# NEWMAR CORPORATION WARRANTY DEPARTMENT

TECHNICAL SERVICE BULLETIN							
DATE ISSUED	MODEL YEAR(S) AFFECTED	MODEL(S) AFFECTED	TSB #				
2/14/01	2001	DS DP	211				
BRAND		TYPE					
All <input type="checkbox"/>	American Star <input type="checkbox"/>	Kountry Star <input type="checkbox"/>	Dutch Star <input checked="" type="checkbox"/>	All <input type="checkbox"/>	T T <input type="checkbox"/>	F W <input type="checkbox"/>	
NewAire <input type="checkbox"/>	Mountain Aire <input type="checkbox"/>	Kountry Aire <input type="checkbox"/>	London Aire <input type="checkbox"/>	C A <input type="checkbox"/>	D P <input checked="" type="checkbox"/>	D B <input type="checkbox"/>	
<input type="checkbox"/> Air Conditioning & Heating				<input checked="" type="checkbox"/> Electrical Components			
<input type="checkbox"/> Appliances & Accessories				<input type="checkbox"/> Exterior Components			
<input type="checkbox"/> Cabinets & Furniture				<input type="checkbox"/> Interior Components

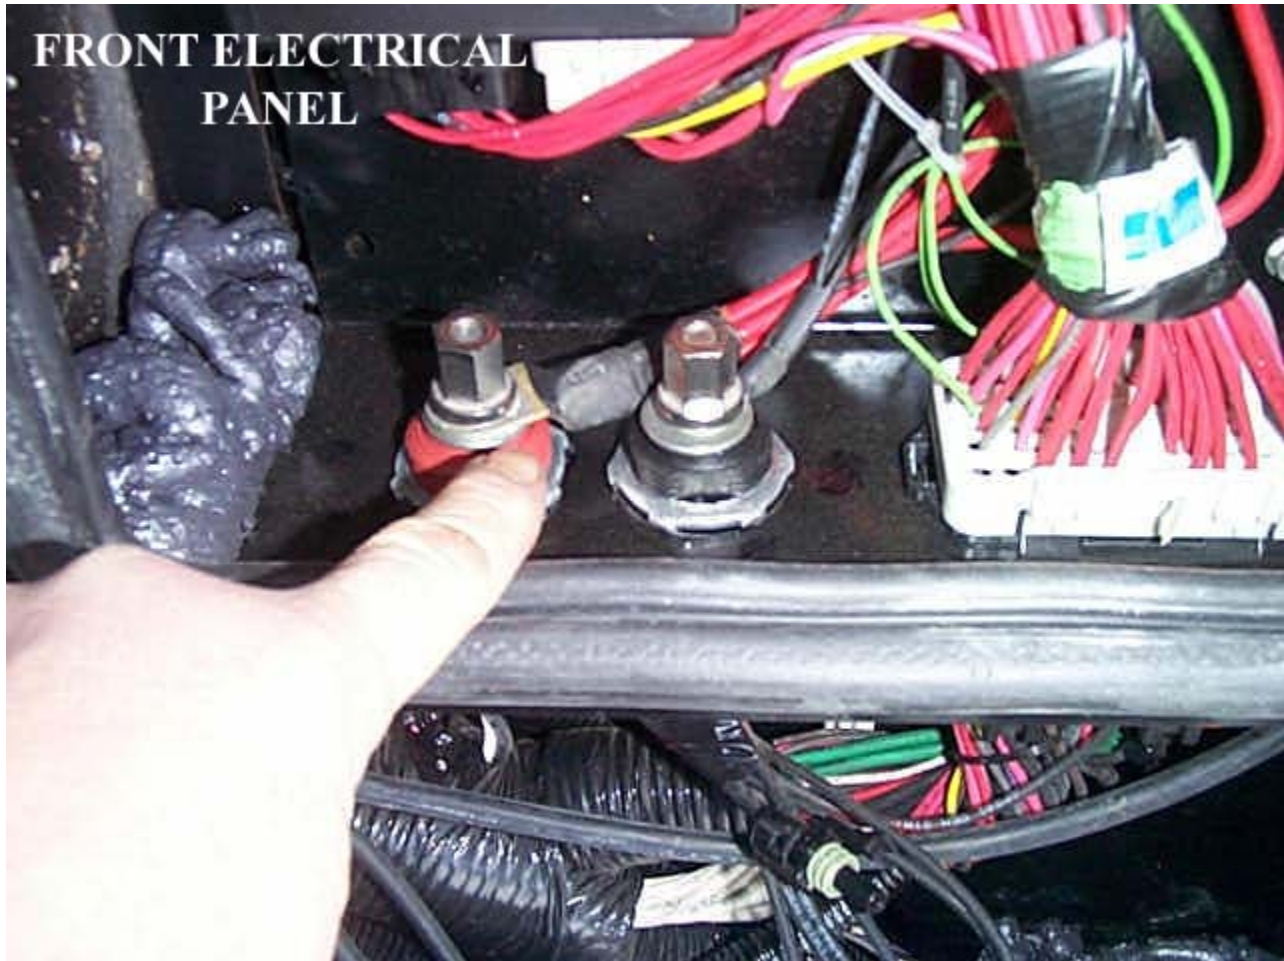
<input type="checkbox"/> Chassis Components				<input type="checkbox"/> Plumbing & Bath Components			
<input type="checkbox"/> Construction Components				<input type="checkbox"/> Windows, Awnings, Vents, & Doors			
DESCRIPTION OF PROBLEM							
Possible exterior lighting blackout on the Spartan chassis. (Headlights, marker lights, etc.)							
RECOMMENDED SOLUTION							
Check and secure the connection as shown in the attached photo.
